Docket No. 50-285

IE Bulletin No. 80-20  
Date: July 31, 1980  
Page 1 of 2

FAILURES OF WESTINGHOUSE TYPE W-2 SPRING RETURN TO NEUTRAL CONTROL SWITCHES

FIGURE 1

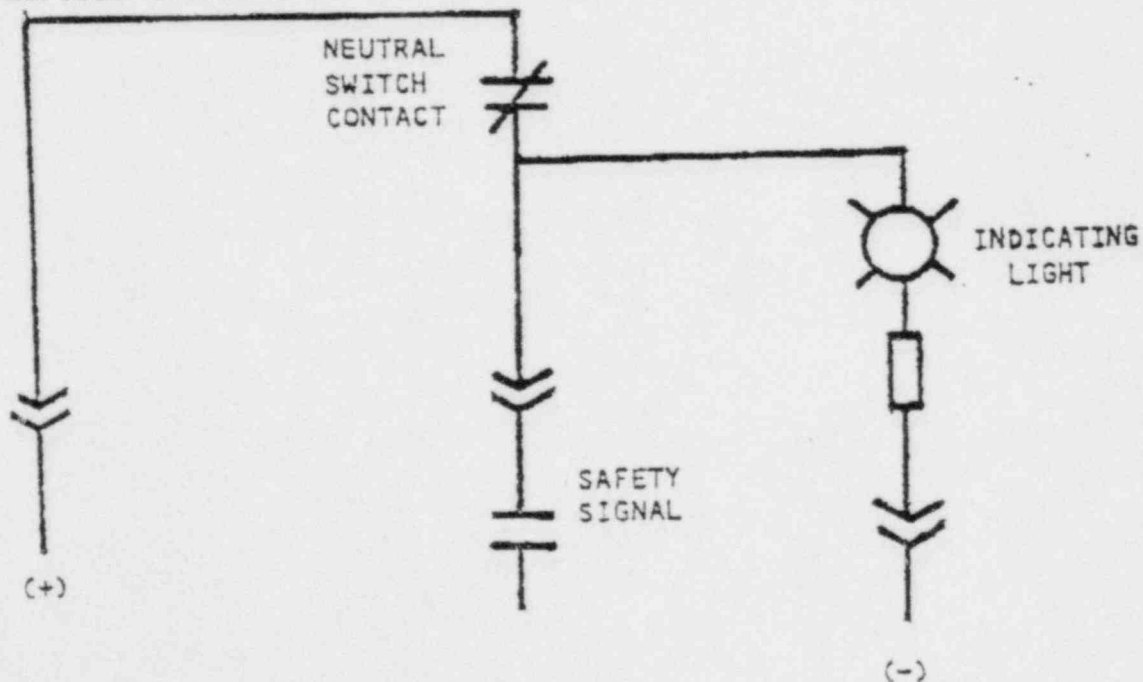
A review of this matter by Westinghouse led to the issuance of NSD Technical Bulletin No. NSD-TB-80-9 to the utility owners of all Westinghouse operating plants. The recommendations contained in the Westinghouse technical bulletin include: (i) testing the neutral position contacts of the subject W-2 switches for continuity, and (ii) rewiring of the indicating light circuit to permit the early detection of a neutral contact failure as shown in Figure 1.

Depending on how the indicating light circuit is wired, loss of continuity thru the neutral position contact of a W-2 switch could remain undetected until the equipment associated with the switch were called upon to operate. Since such a failure would be equivalent to by-passing the system associated with the switch, consideration should be given to rewiring the switches used in safety-related applications as shown in Figure 1. Such rewiring would provide an acceptable means for detecting contact failure, provided the indicating light is in the control room and readily visible by the operator. If the indicating light is not so located, consideration should be given to annunciating the neutral position contact failures at the control room to alert the operator of the inoperable status of a safety-related system. In addition, consideration should be given to adding redundant contacts to the W-2 switches or to replacing the W-2 switches with others having a more positive contact wiping action.

3. Licensees of operating plants and holders of construction permits shall describe the longer term corrective measures planned and the date by which such measures will be implemented by actual installation or by design change, as appropriate. As a minimum, the longer term corrective measures should include rewiring the indicating light as shown in Figure 1 provided the light is readily visible to the control room operator. If not, failures of the neutral position contacts should be annunciated in the control room.

EXISTING INDICATING LIGHT CIRCUIT (TYPICAL)

PROPOSED REWIRING OF INDICATING LIGHT CIRCUIT (TYPICAL)

REWIRING OF INDICATING LIGHT CIRCUIT OF W-2 SWITCHES  
AS RECOMMENDED BY WESTINGHOUSE TECHNICAL BULLETIN NSD-TB-80-9
